A-6-COR-16-0097 (CORONADO PUBLIC FACILITIES ENHANCEMENT PROJECT)

CORRESPONDENCE

**Re: Response to Coastal Commission Staff Report and Recommendation on Appeal de
Novo Coronado South Beach Restrooms, Coronado, California
Appeal No. A-6-COR-16-0097**

City of Coronado Proposed Restroom at Avenida del Sol: Technical Review

Source: South Beach Restroom Project Draft EIR, Figure 5-4, *Visual Simulation – North, Future Raised Road*.

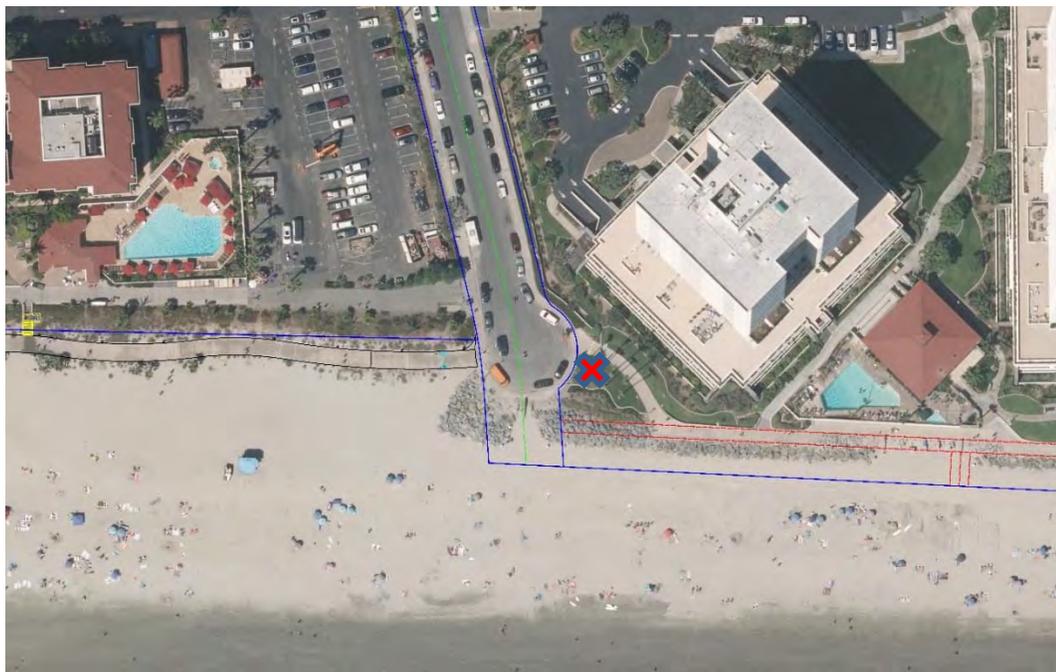
Simulated view of the project site from the same location, assuming Avenida del Sol is elevated approximately 4.5 feet, as proposed in the approved Hotel del Coronado Amended Master Plan Project.

Contrary to CCC’s finding on this alternative that “[b]ecause the facility would be on the northern edge of Avenida del Sol, impacts to public views could be minimized,” the City believes removal of the existing temporary trailer and placing the permanent facility out of line of sight (such as the proposed location) would significantly improve ocean views from Avenida del Sol. As the restroom building at the proposed location would be less obtrusive than this alternative, the proposed project would be environmentally superior to this alternative.

Figure 1. The site of the proposed restroom at the end of Avenida del Sol in the City of Coronado. (Thin yellow lines show locations of beach profile analysis)

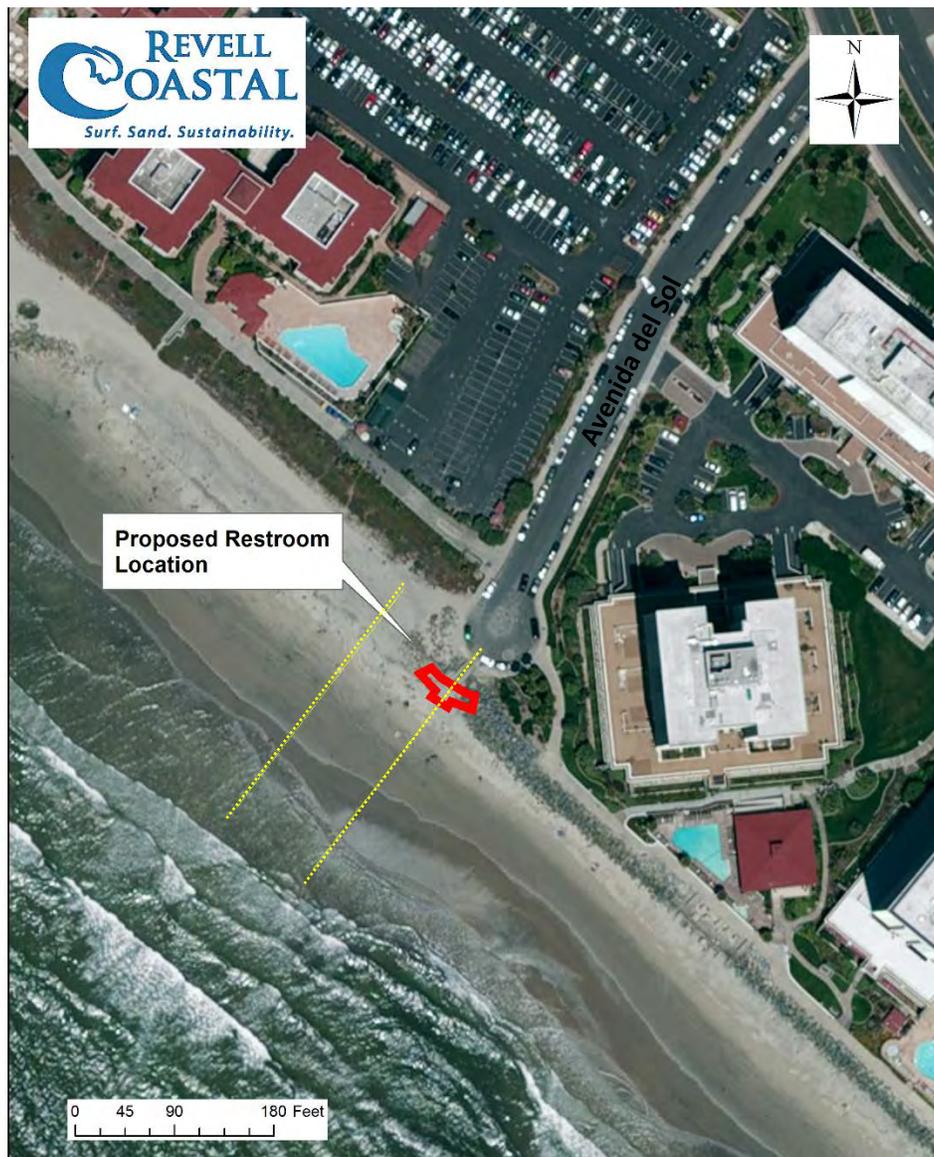
The restroom is proposed for South Beach in Coronado at the end of Avenida del Sol (Figure 1).

**Figure 2. Proposed restroom site in 2016 (top Photo D. Revell) and during the 1982-83 El Niño (Photo C. Miller)
Note approximate location of the proposed restroom and the same light pole.**

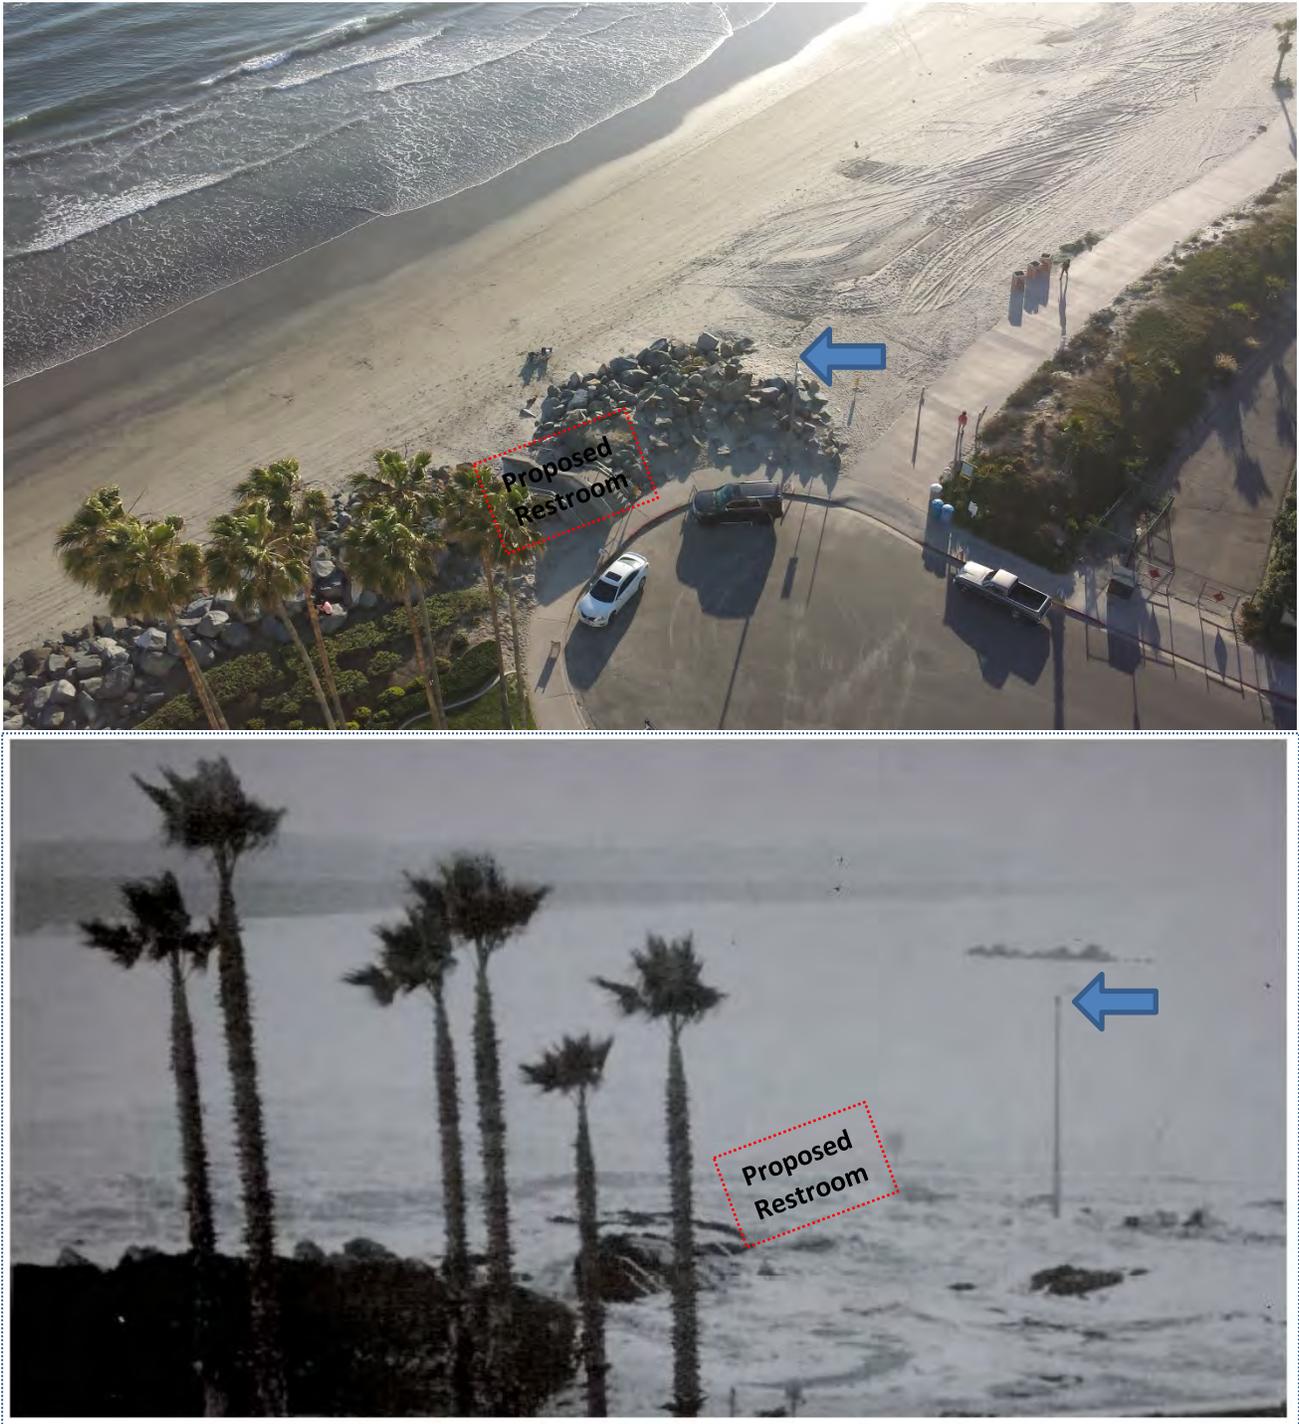
Anecdotal and observational evidence have clearly shown that large historic storm events already pose substantial risk to the proposed site (Figure 2).

Figure 3. Beach profile changes at the proposed restroom location

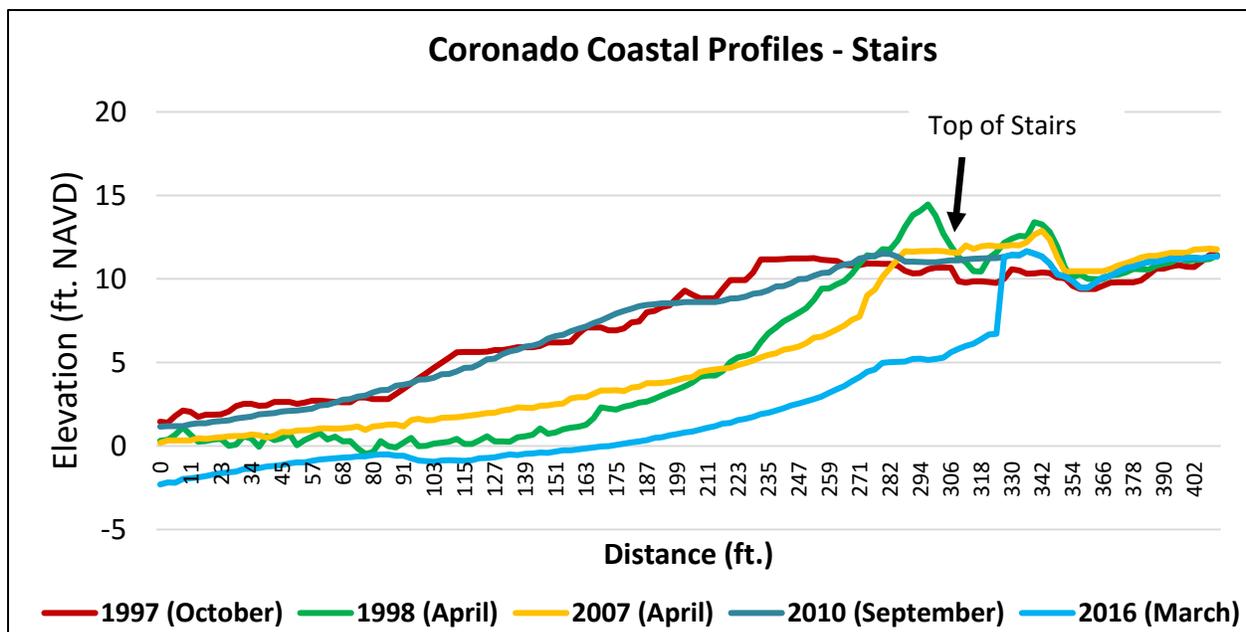
The results from the beach profile analysis at the proposed restroom site are shown in Figure 3 and Table 1. For this discussion, beach width was defined the same as the Terra Costa Group report, and extends from the back of the beach to the NGVD plane (2.2' NAVD). These beach profile results show several pieces of information:

- During the analyzed period, the beach has narrowed by 213 feet, due to both seasonal and El Niño impacts
- The beach narrowed by 145 feet during the 1997/98 El Niño.
- Beach elevations near the stairs have shown scour of a maximum of 9.3 feet following the 2015/16 El Niño. This scour can be seen in Figure 4.

Figure 7. Tsunami Inundation map excerpt from California Geological Survey (2009).

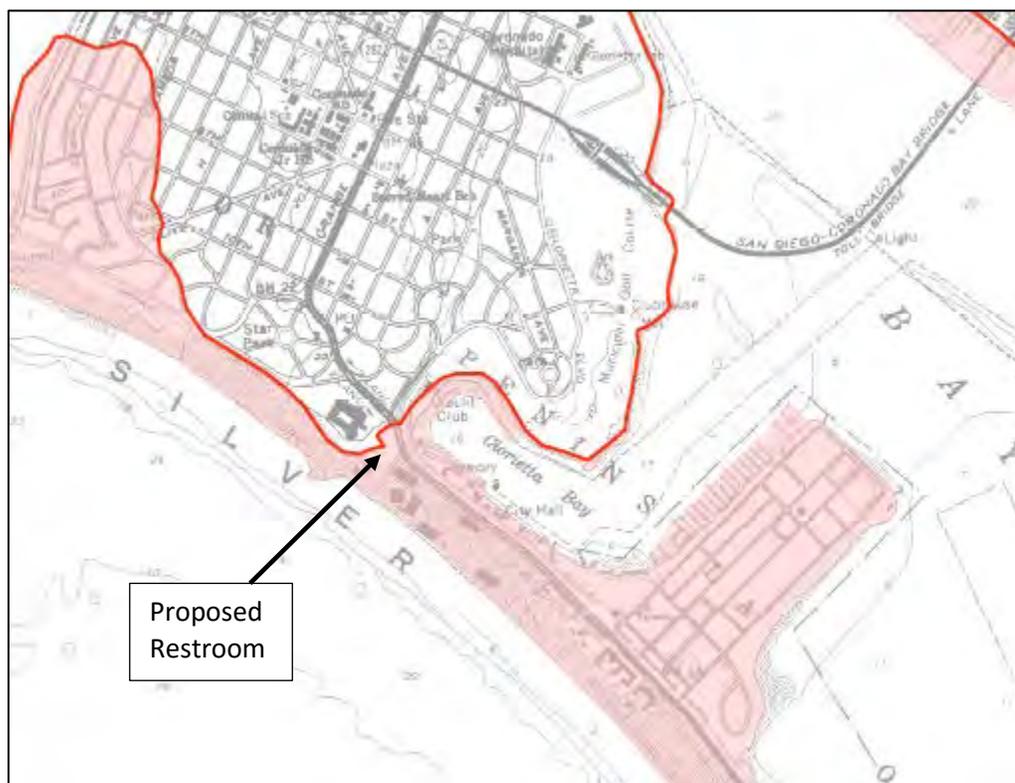
The California Geological Survey has recently completed modeling of potential tsunami inundation (Figure 7) (2009). The inundation map was compiled with best currently available scientific information and included analysis of local earthquake derived sources and submarine landslides, as well as distant sources like Chile or Alaskan earthquakes. The inundation line (shown in pink) represents the maximum considered tsunami runup from a number of extreme, yet realistic, tsunami sources. Tsunamis are rare events and due to a lack of known occurrences in the historical record, there are no probabilities assigned to this tsunami. From the mapped results it is easy to see that the proposed site is in the tsunami hazard zone.

Figure 8. Coastal Flooding Results of the COSMOS 3.0 model showing wave induced coastal flooding for Baseline existing conditions (2010 topography), 0.5 meters, 1.0 meters, and 2.0 meters of sea level rise.

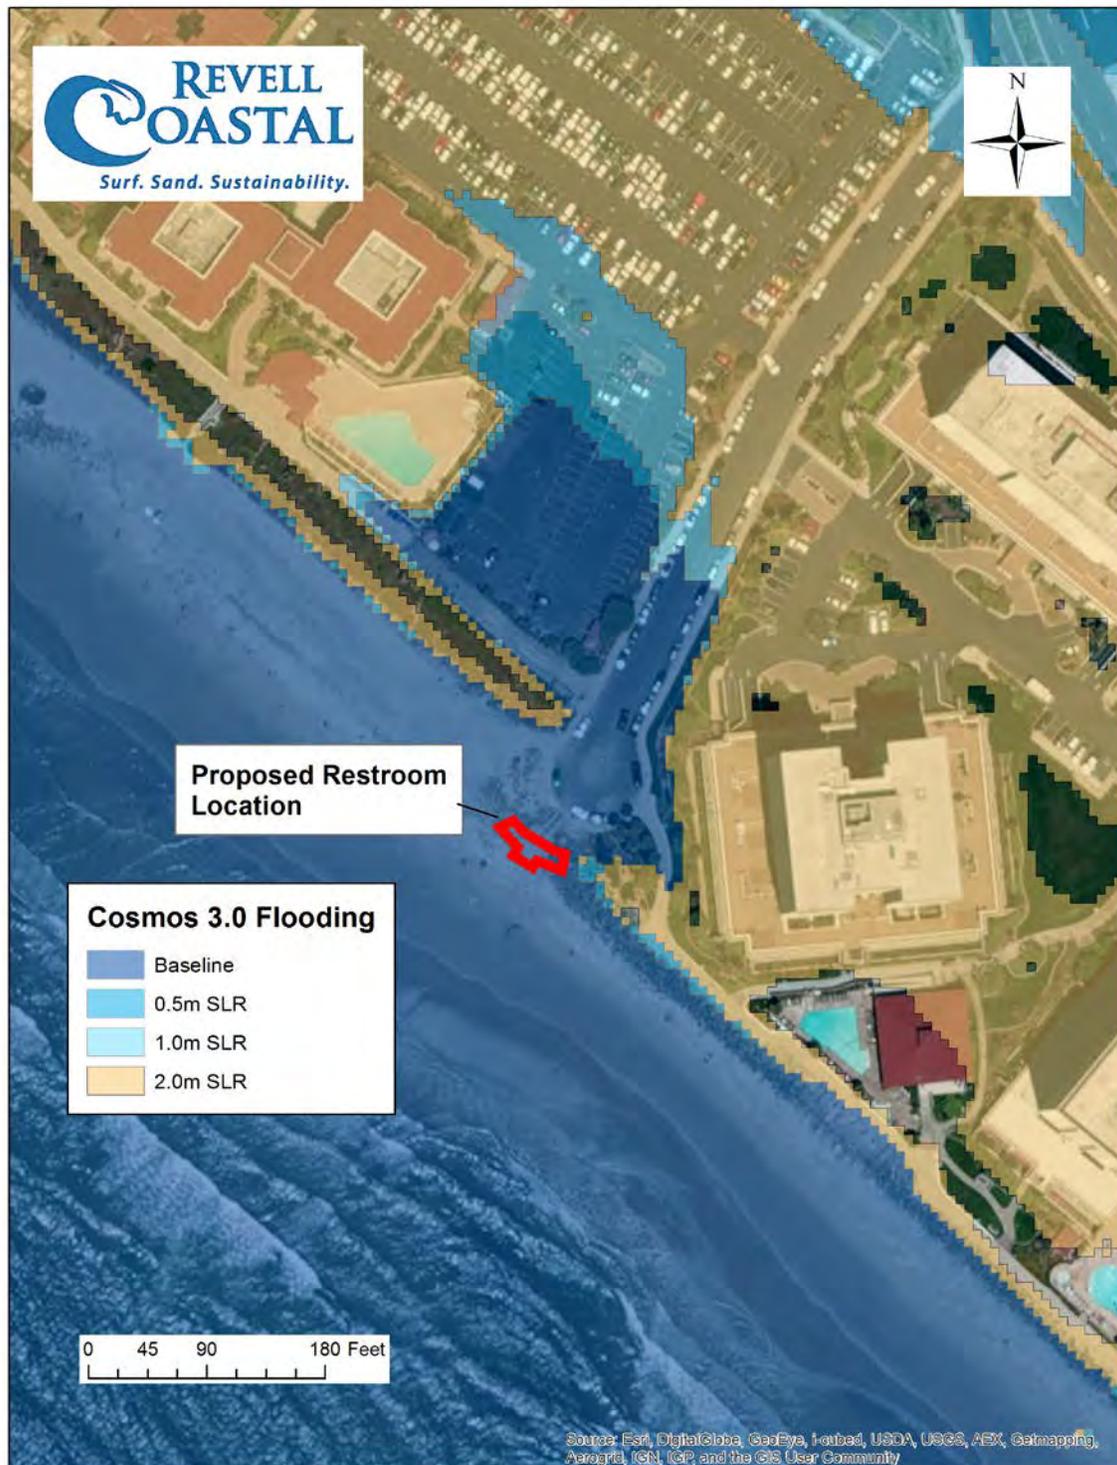
Results of the Initial USGS COSMOS 3.0 coastal flooding model show that the existing site is already susceptible to wave overtopping and coastal flooding (Figure 8).
